FINAL DEVELOPMENT PLAN

FED ONE
CLAYCRAFT WAREHOUSE
CITY OF GAHANNA
FRANKLIN COUNTY, OHIO

Subject: Claycraft Warehouse- Design Review Comments
City of Gahanna, Franklin County, Ohio
CEC Project 182-564

RE: Project 870 Claycraft Rd Design Review Comments

SITE PLAN

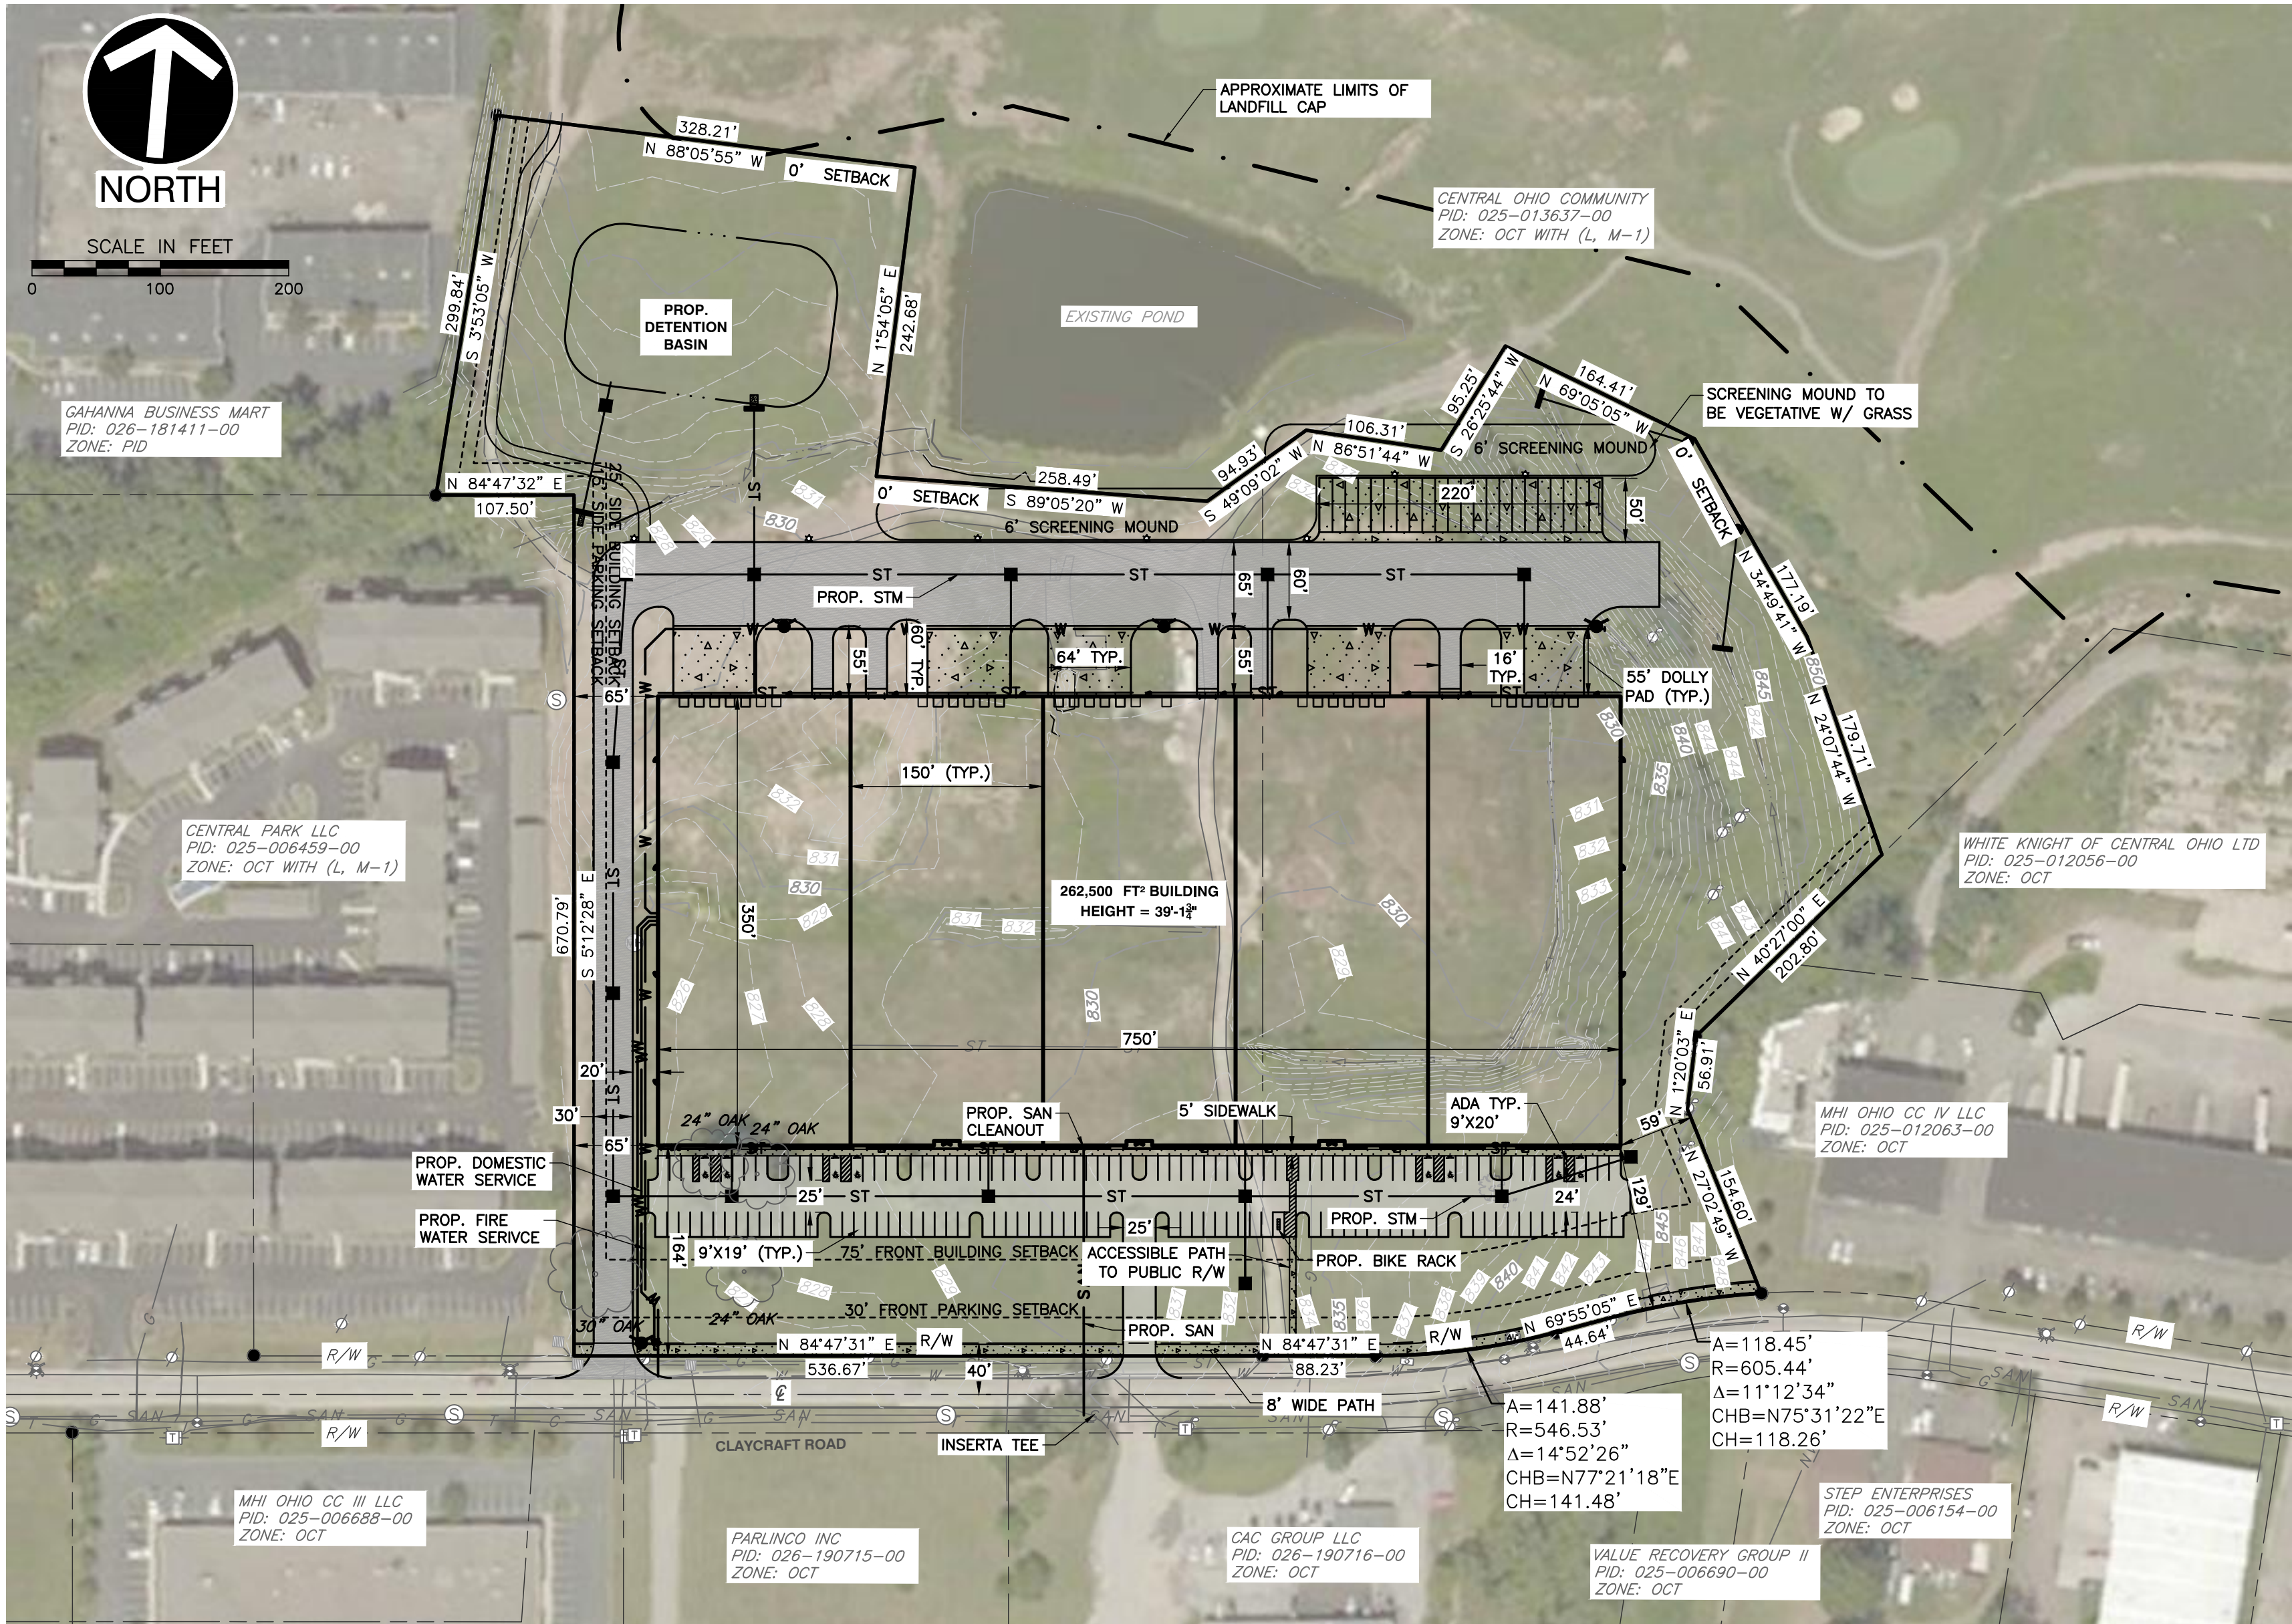
3. I only have one comment regarding 870 Claycraft. The proposed detention basin is in the path of the overflow from the adjacent pond. As shown, the detention basin will intercept the surface flow from the pond. The final design plan should address the emergency overflow from the offsite pond and potential impacts to their detention basin outlet.

The building is 262,500 square feet and the height is 39' 1", which requires a fire flow of 8,000 GPM. But since the building is going to be fully suppressed, the minimum fire flow required is 2000 GPM or 25% of the value of Table B105.1 (2).

The minimum number of fire hydrants is 2 in accordance with Table C102.1. There are 3 fire hydrants on the south side of the building and 2 public fire hydrants are located on Claycraft Road, located in front of the building. There has been an additional hydrant placed on the plans at the west entrance to the warehouse.

Since the height of the building from the ground to the building eaves exceed 30 feet, the drive lane of the fire apparatus roadway shall be 26 feet in width for aerial access. The proximity to the building shall be not less than 15 feet from the building and no more than 30 feet from building and positioned parallel to one entire side of the building. The rear of the building does not meet the requirements of a fire department access road since it exceeds the 30 foot distance from the building. But there are 55 foot sections of heavy duty road that are in front of each set of bay door and the aerial could set up there if needed. The Fire Division approves this project plan.

OK as noted.

OK as noted.

1/32" EXTERIOR ELEVATIONS

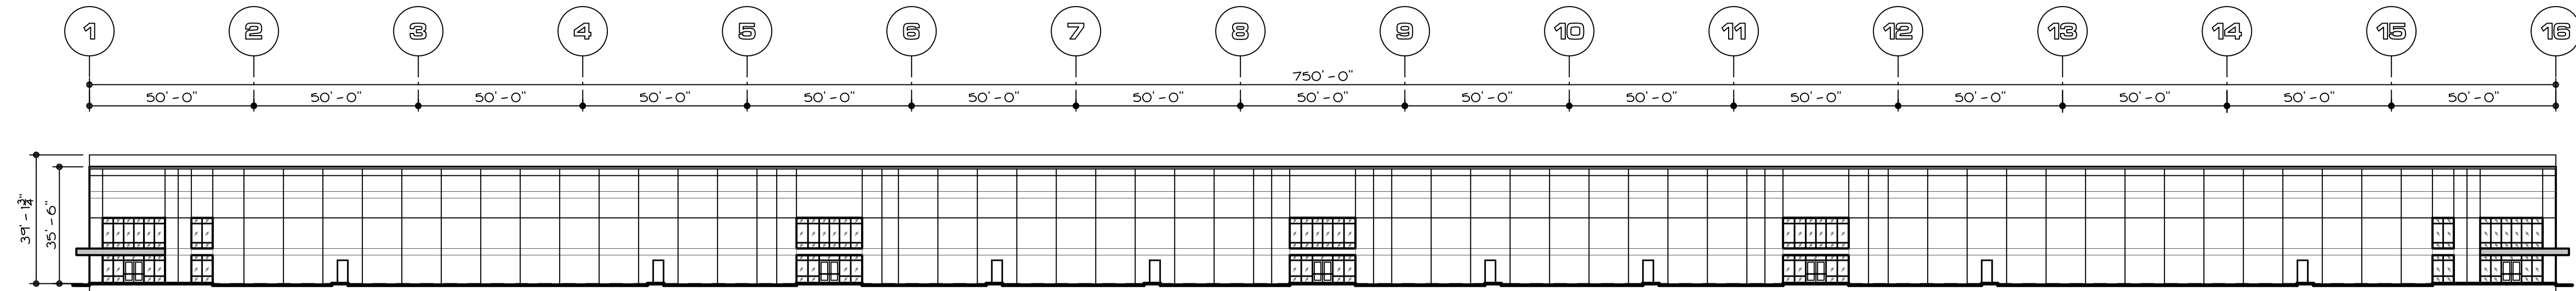
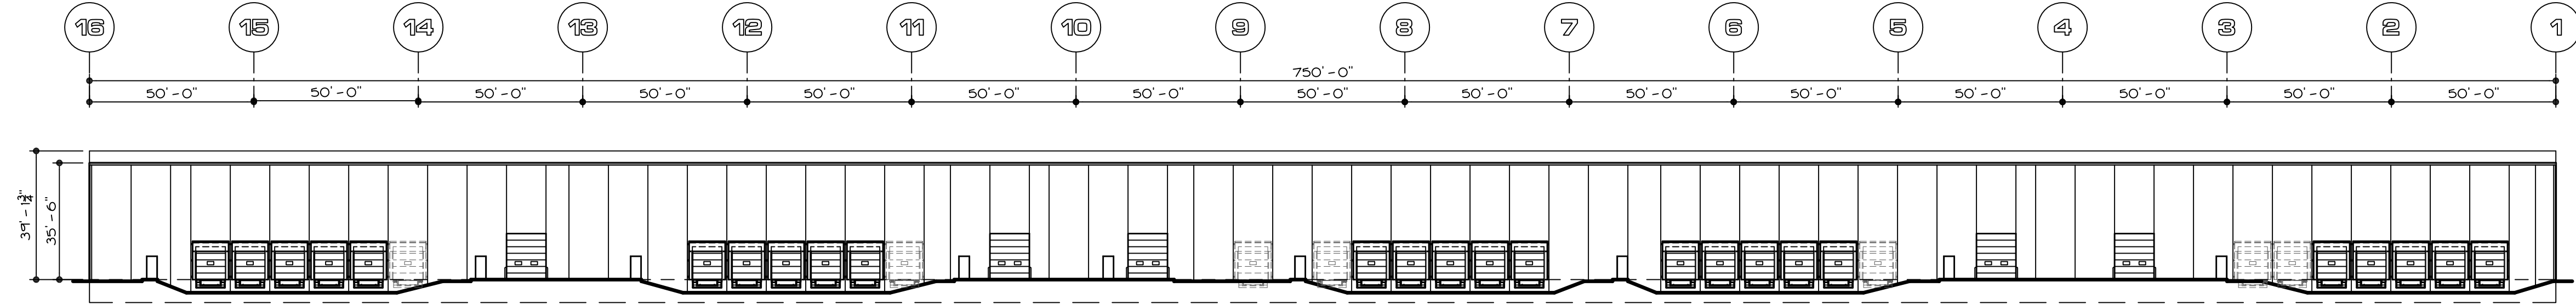
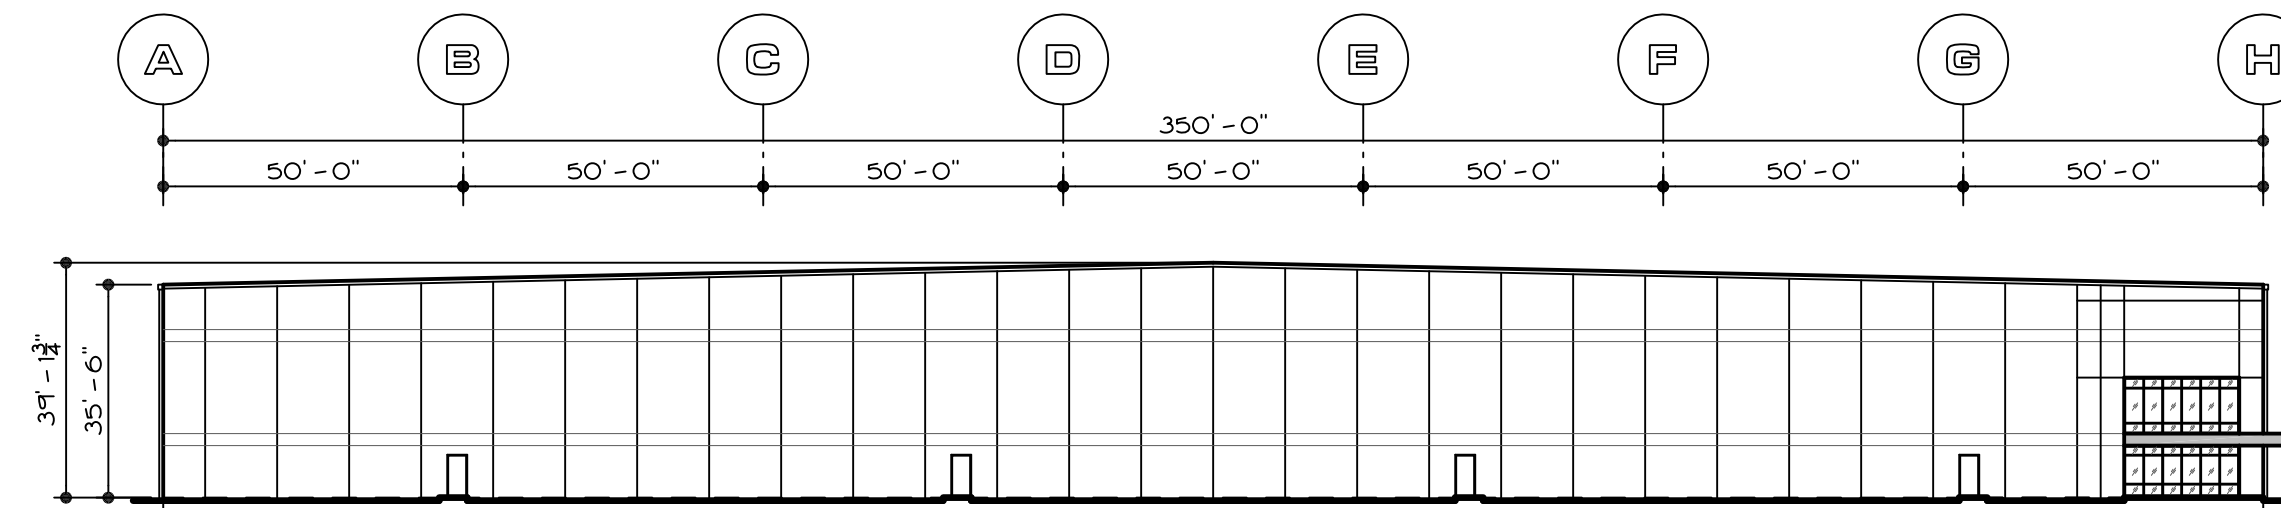
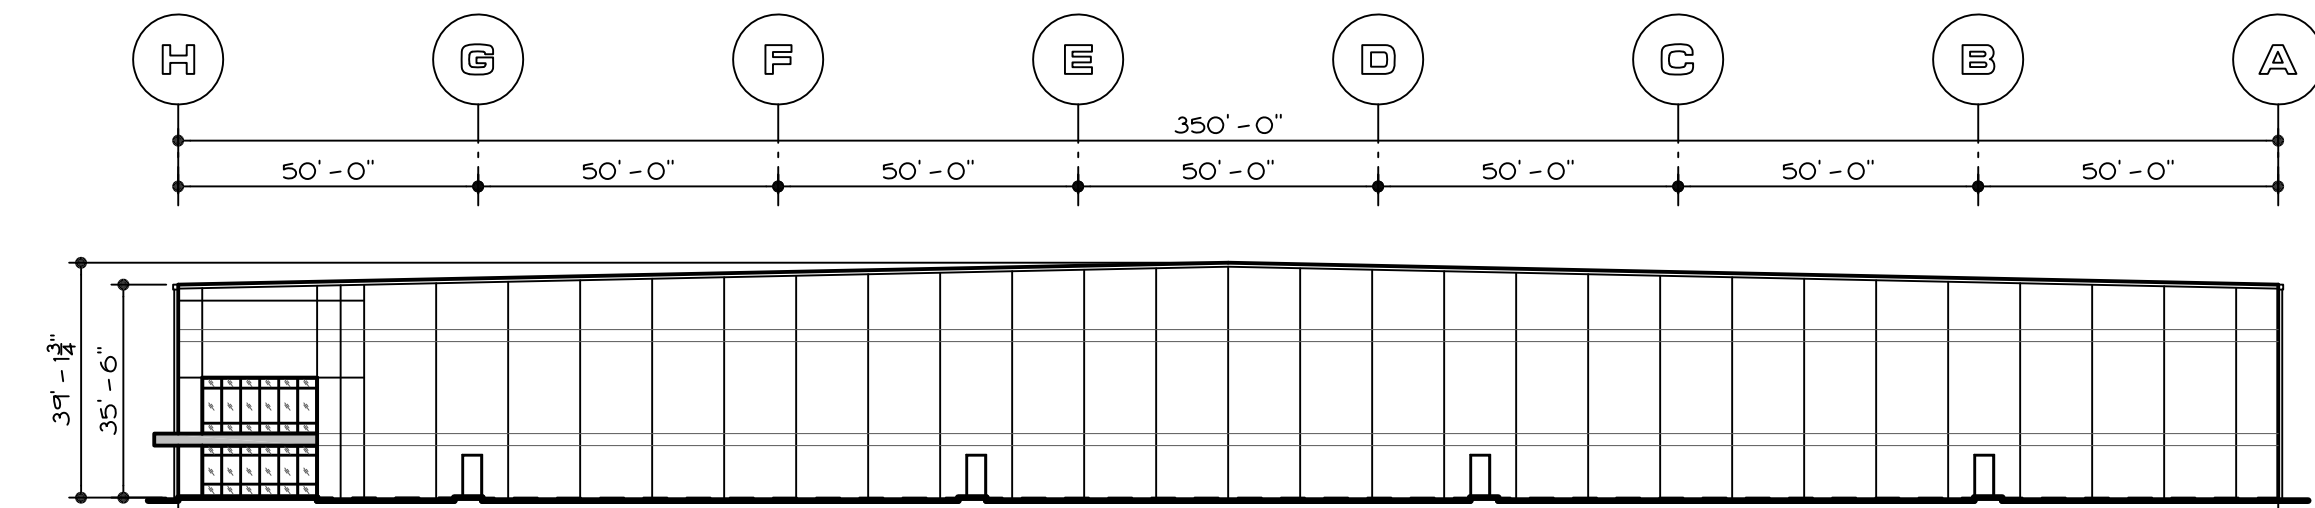
6. Page 7 of 14 of the overlay text requires the main facade of all buildings to incorporate a minimum of 50% brick or stone. Please revise the request accordingly or seek a variance.

12/10/18 - A variance to this standard has been requested.
